Technical Memorandum on Evaluation on 2018 Proposed SWRP NPDES Discharge Permit.
Jacobs Engineering Group Inc. June 22, 2018.

Subject Evaluation of 2018 Proposed
SWRP NPDES Discharge Permit

Attention John Stomp/Water Authority

Date June 22, 2018

Figure 5: Water Balance September 8, 2013, Rio Grande at Central

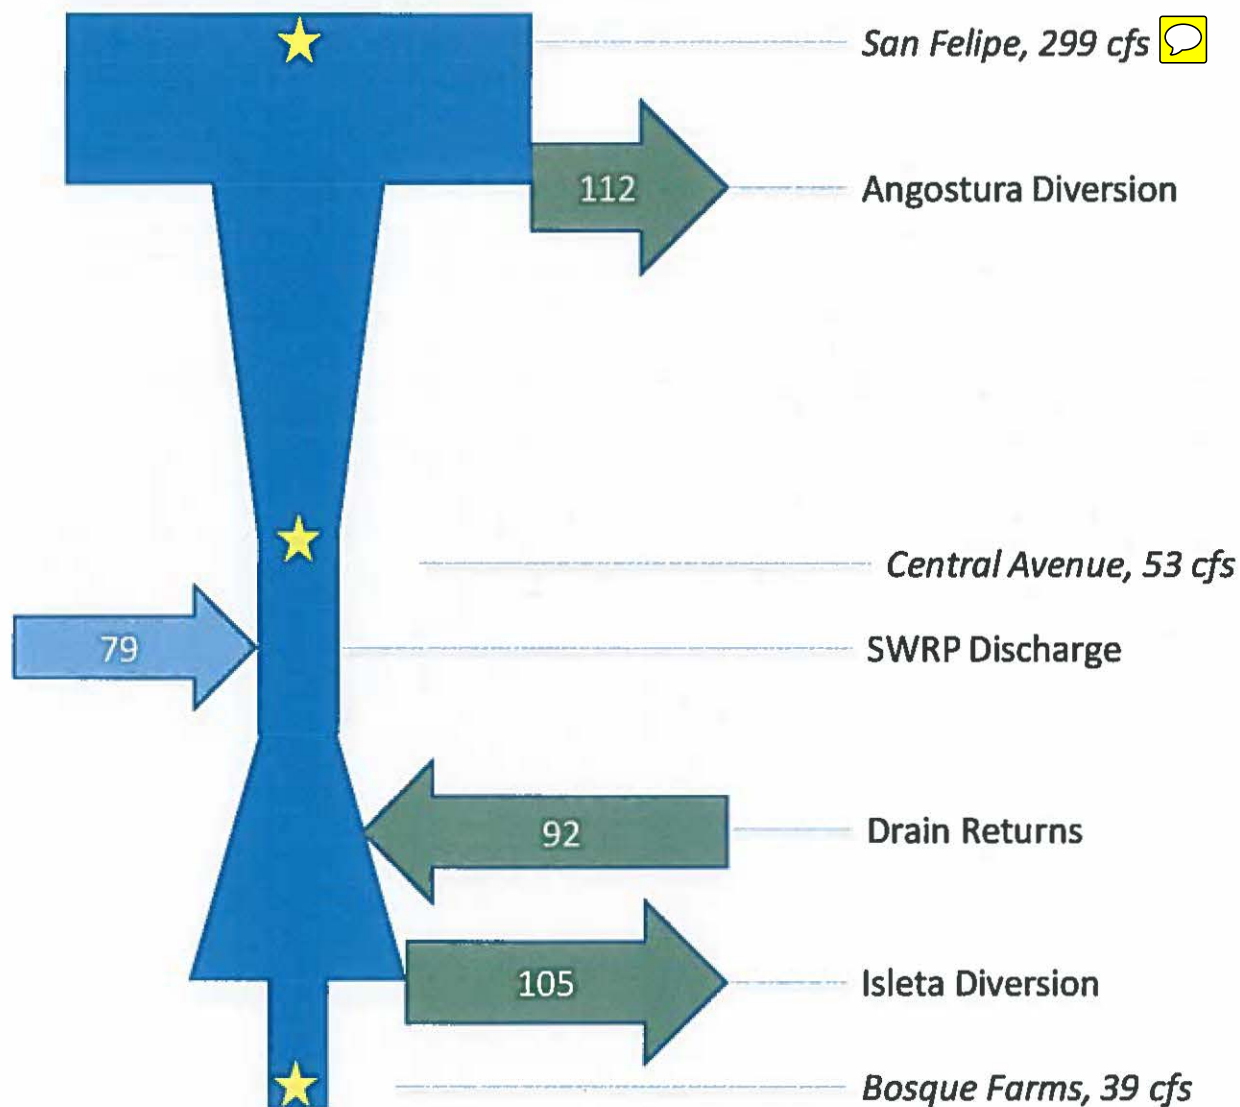
On the low flow day in question, 112 cfs was diverted at Angostura, almost half of the flow of the River. Additional losses occurred through seepage from the Rio Grande to the riverside drains, which comeingle with water diverted at Angostura and is either passed through the irrigation system or returned to the River. Table 5 presents available data for September 8, 2013. These data show the noted 112 cfs diversion at Angostura and the 53 cfs measurement¹⁰ at Central. Note also that 92 cfs of water is returned to the River below Isleta Lakes and above the Isleta Diversion. This is water that is available downstream of Central Avenue that was not recorded at the Central Avenue gage. Also note that approximately 105 cfs was diverted at Isleta, effectively resulting in drying below the diversion. This diverted water was combined with water passed from the Albuquerque Division via the irrigation system—the remaining drain flow and original diversion at Angostura. Figure 4 shows a pipe diagram of the Rio Grande by river location for September 8, 2013. Figure 5 shows a simplified version with only the major diversions and discharges.

Figure 6: Historical Low Flows, Rio Grande at Central

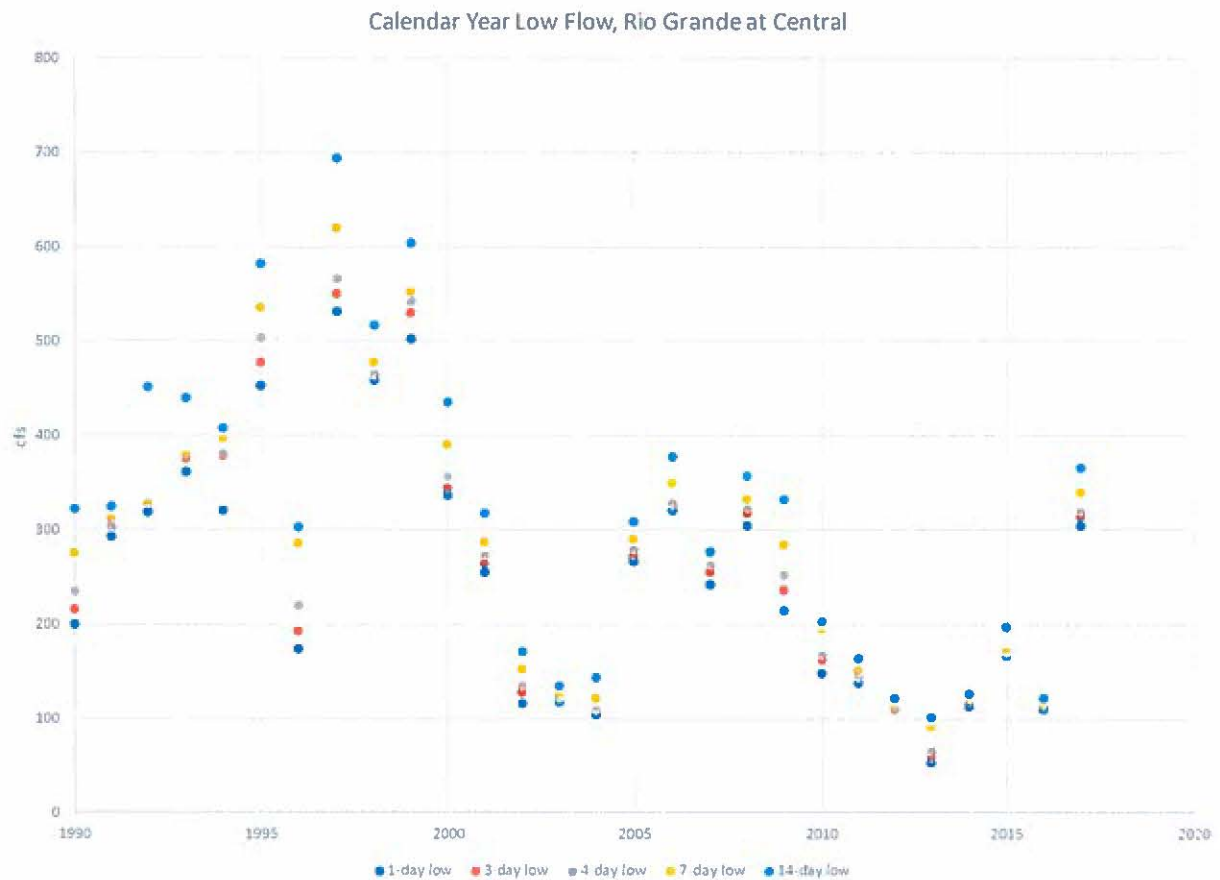
Historical low flows of the Rio Grande at Central are presented in Figure 6. 2013, the year in which the noted daily average low flow of 53 cfs was observed, is the only year that had single-day flows below 100 cfs (during the period 1997-2017). 2004 had the next lowest single day flow, at 104 cfs. In 2013, the lowest 7-day average flow was 91 cfs, and the lowest 14-day average flow was 101 cfs. These statistics suggest that the low flow of 53 cfs was a rare occurrence.

Figure 7: Frequency of Flow Rates, Rio Grande at Central, 1997-2017

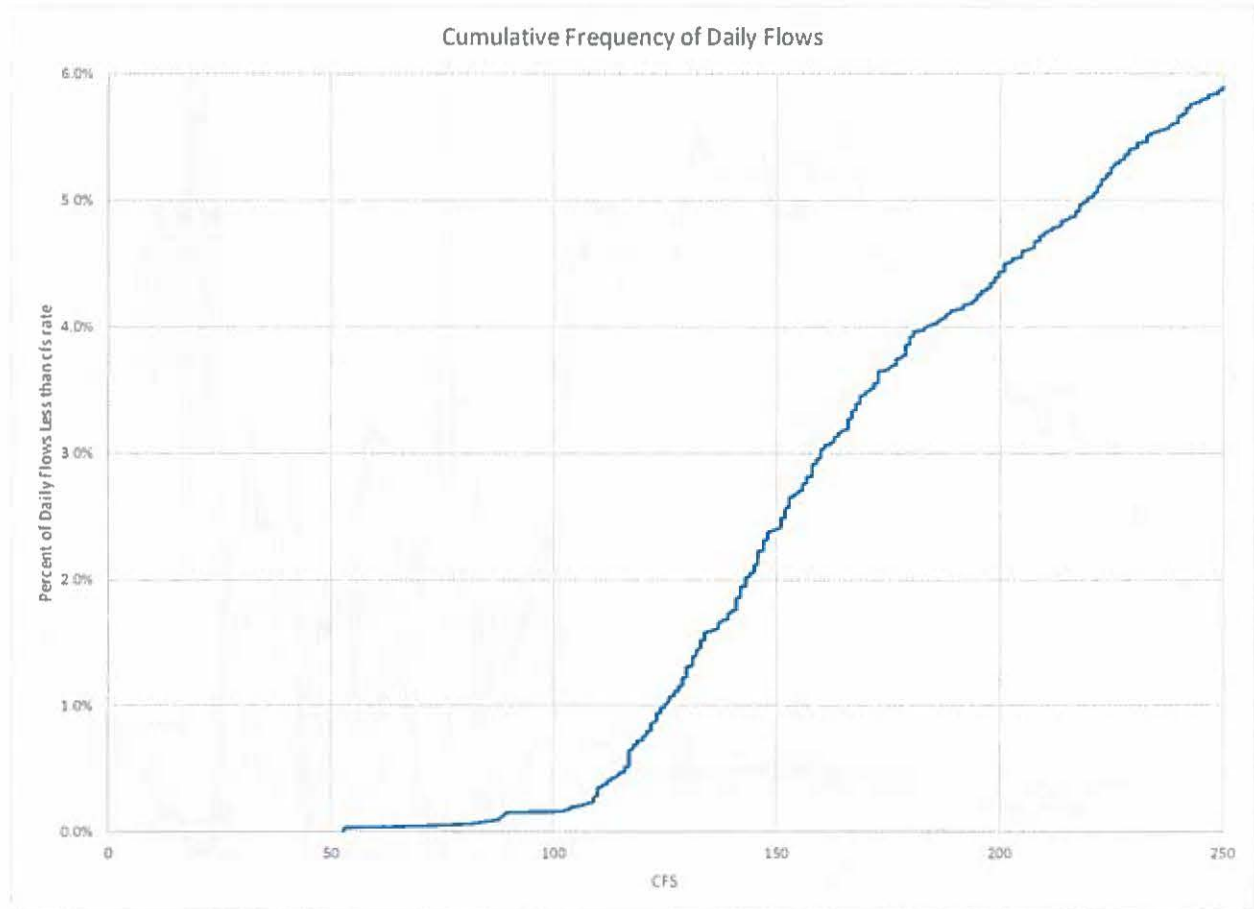
The rarity of this low flow can also be seen in a plot of frequencies of low flows (Figure 7). Over the 20-year period 1997-2017, only 11 days (0.16 percent of days in the 20-year record) had flow less than 100 cfs. All of these days occurred in 2013.

Figure 8: Rio Grande Flows and Diversions at Central and Upstream, 2013 (data from USGS and MRGCD/US Bureau of Reclamation)

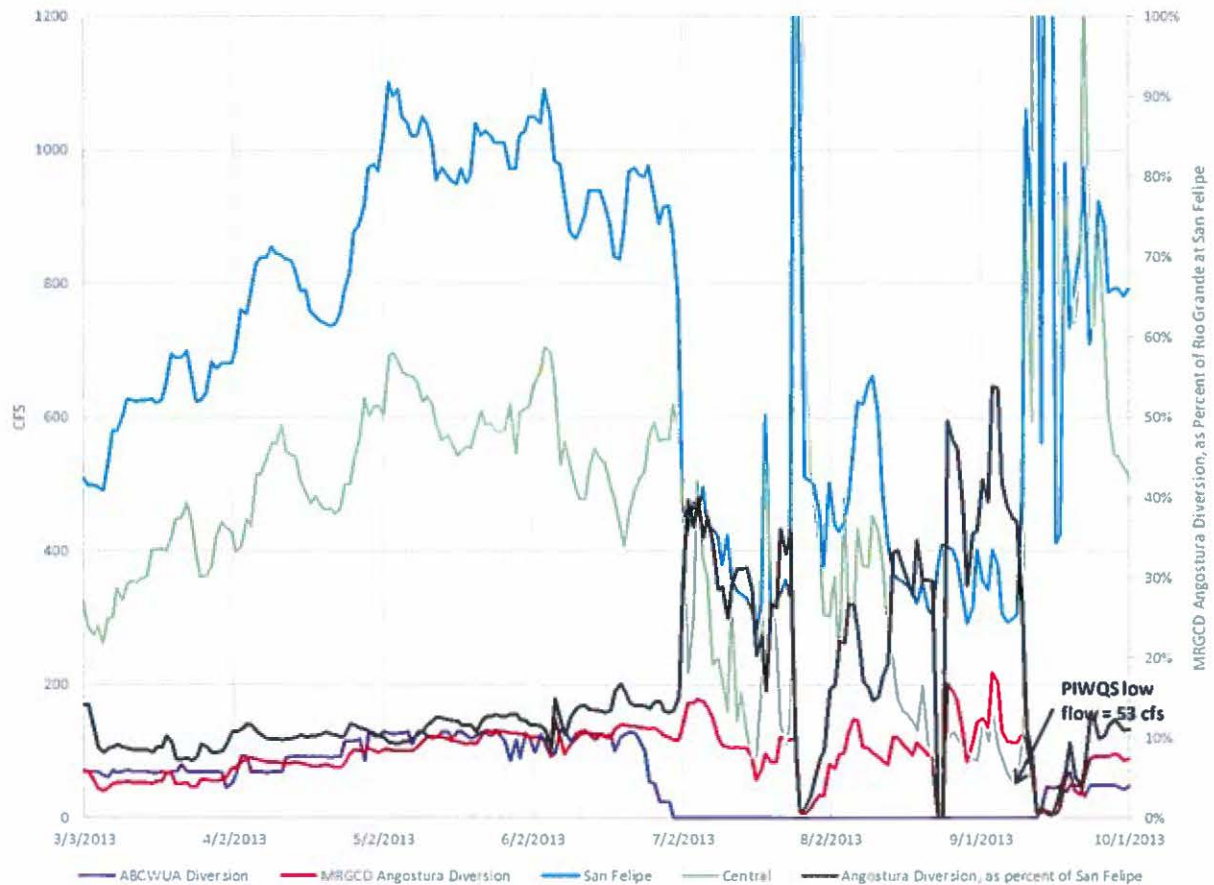
Time-series data of flow in the Rio Grande, along with diversions, are presented in Figure 8. All 11 of the dates with flow at Central less than 100 cfs are included in Figure 8; however, MRGCD's datasets are missing data for 2 full days of these 11 days. The following conclusions can be drawn from Figure 8:

- During all 9 days with flow at Central less than 100 cfs and MRGCD data available, MRGCD was diverting a significant amount of water from the Rio Grande at Angostura

- On average, MRGCD's Angostura diversions were greater than 100 cfs on those 9 days, and in some cases exceeded 50 percent of flow in the Rio Grande at San Felipe.

- The Water Authority was not diverting water for the Drinking Water Project during any of these low-flow events. The Water Authority was releasing a small amount of water (about 8 cfs) from Abiquiu for diversion at the North I-25 non-potable project (Figure 9). The low flow dates in 2013, including the PIWQS flow rate of 53 cfs, are artificially low due to MRGCD diversions during low-flow periods.

Figure 9: Releases of San Juan-Chama Water from Abiquiú, 2013 (data from Upper Rio Grande Water Operations Model (URGWM))

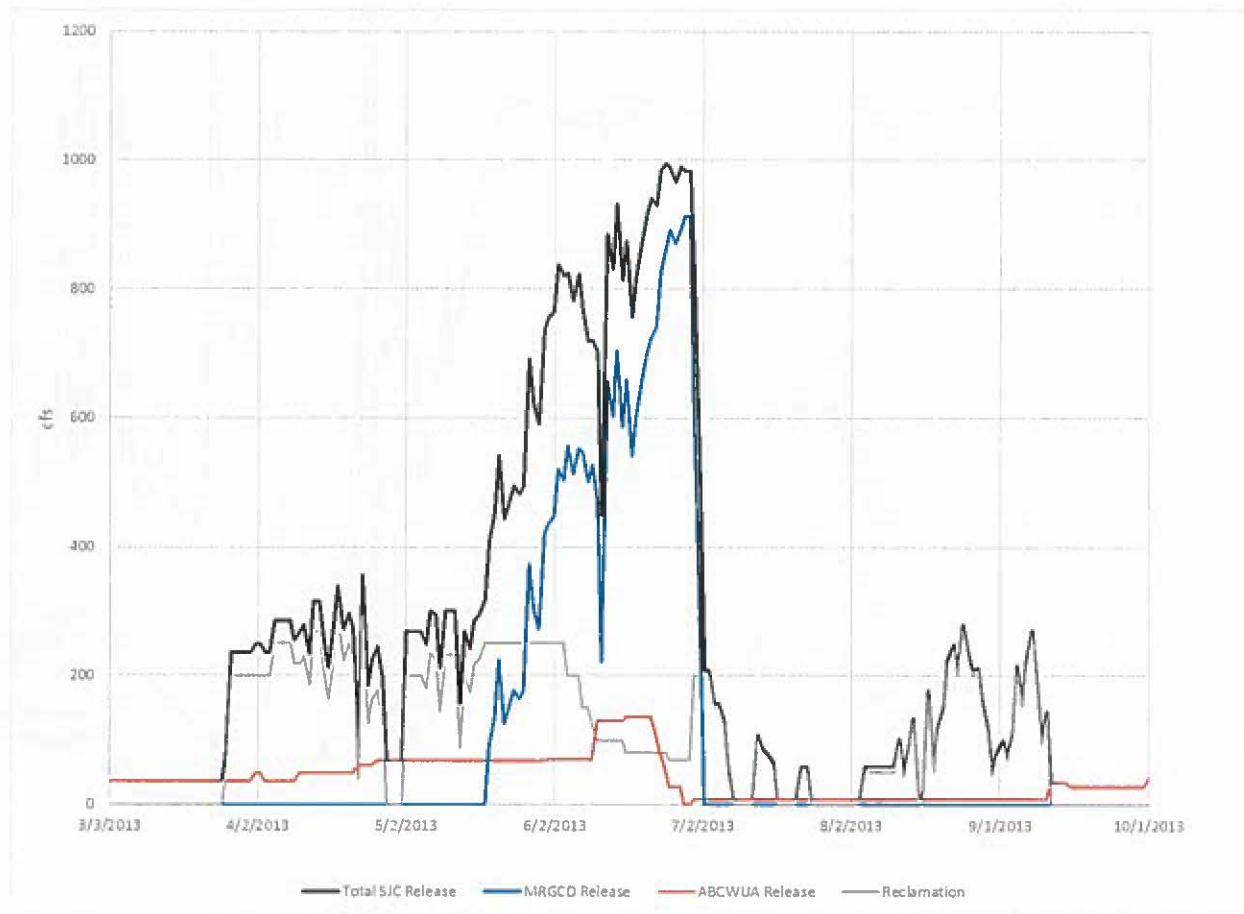
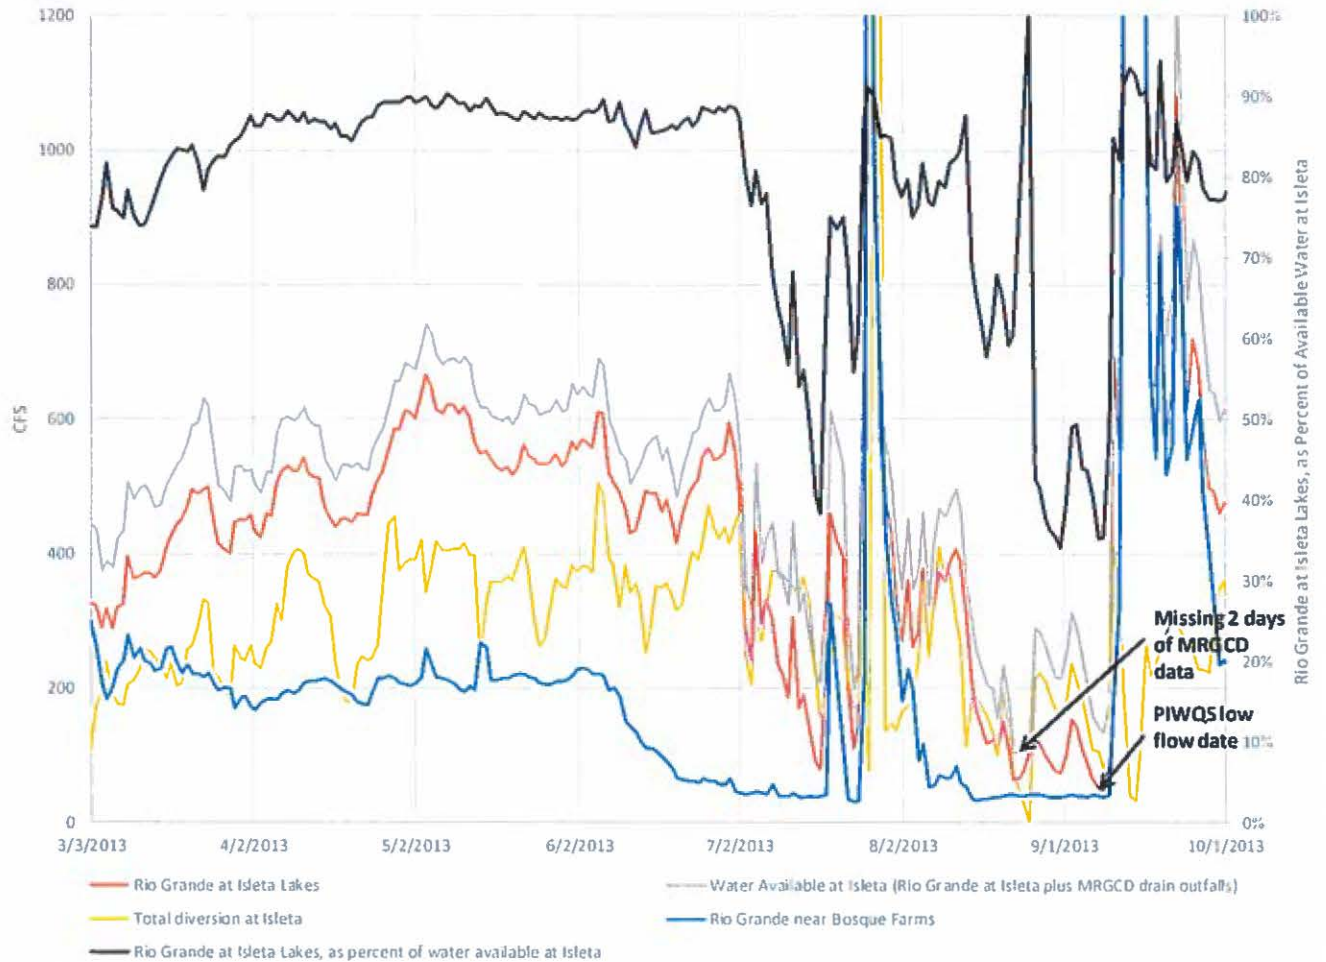
- Note that MRGCD released San Juan-Chama water only through July 2 (Figure 9); accordingly, MRGCD's diversions during the low flow periods were of native Rio Grande water only.
